## Technology Inclusive Risk Informed Change Evaluation (TIRICE)

Guidance for the Evaluation of Changes to Facilities  
Utilizing NEI 18-04 and NEI 21-07

Prepared by the Nuclear Energy Institute  
March 2023

Figure 4. Modification to Add Second Solenoid Valve in Example 1

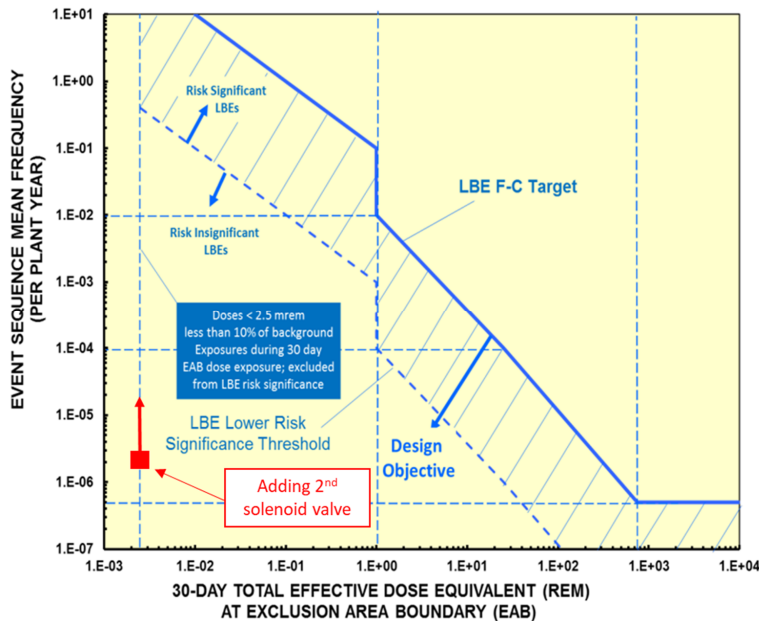
**Commented [A37]:** What's meant by "unacceptable stress" ? Inside or outside of AOO assumptions and related limitations?

**Commented [A38R37]:** The example has been revised to illustrate a proposed change that results in a dose associated with an AOO of 110 mrem would be "unacceptable."
